Technical Service Bulletin No. 26

Reference no: Sense fault on PLM

PLM Series (PLM 10000Q, PLM 14000 and PLM 20000Q)

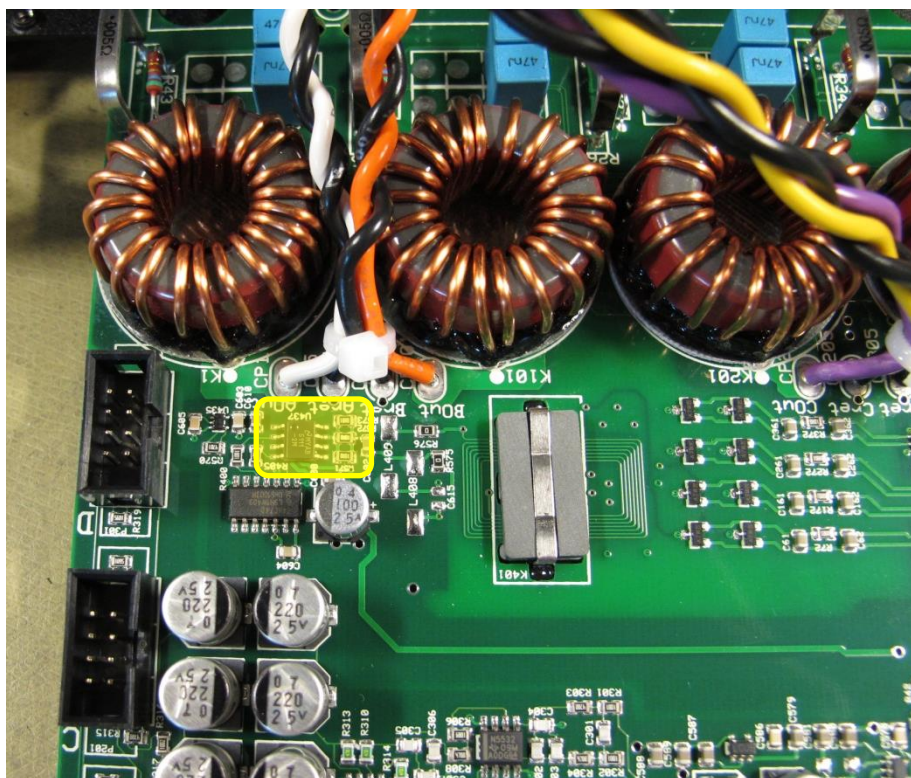
9.	Highlighted with yellow, area with U437, R571, R572 and R573.		
----	---	--	--

Replace IC U437 and resistor R571, R572 & R573.

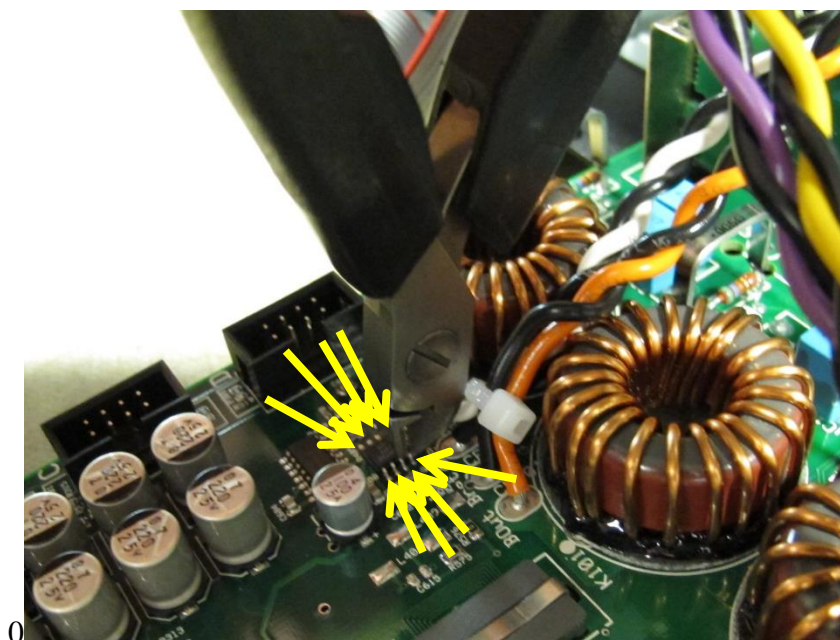
10.	Cut of the eight legs of U437.		
-----	--------------------------------	--	--

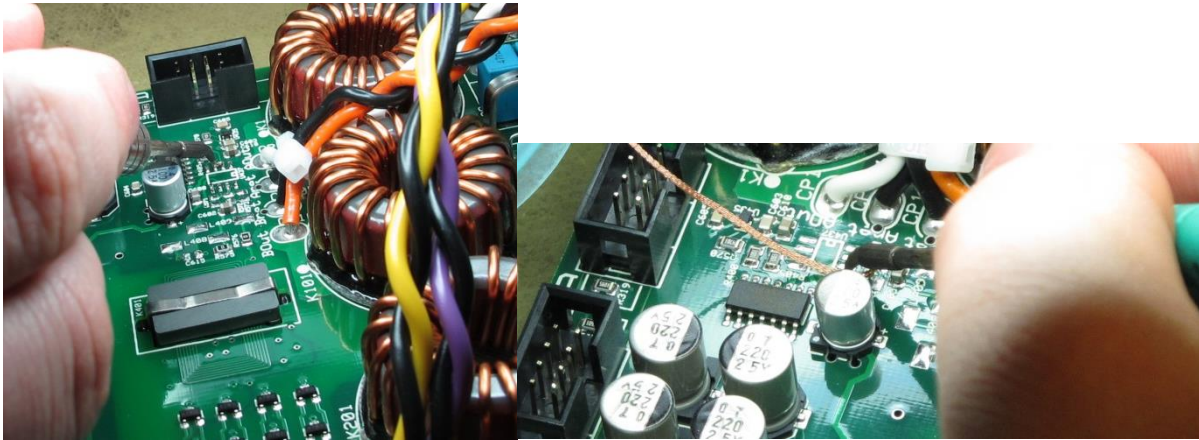
11.	Just lift away the IC, and clear the pads with soldering iron from the IC leg parts, and clean the pads from solder.		
-----	--	--	--

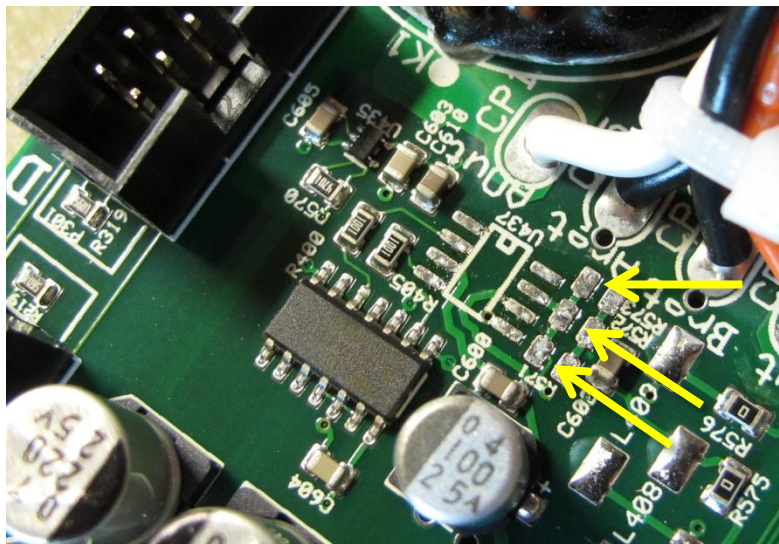
12.	Remove the resistors R571, R572 and R573.		
-----	---	--	--

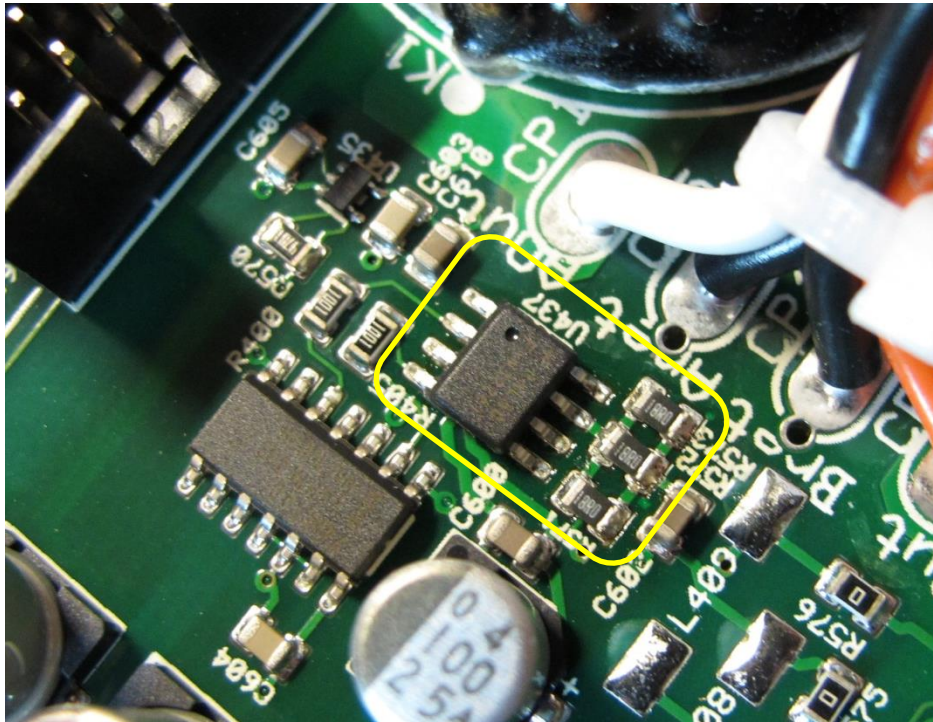
13.	Mount and solder on the new components.	U437	1
		R571, R572, R573	2
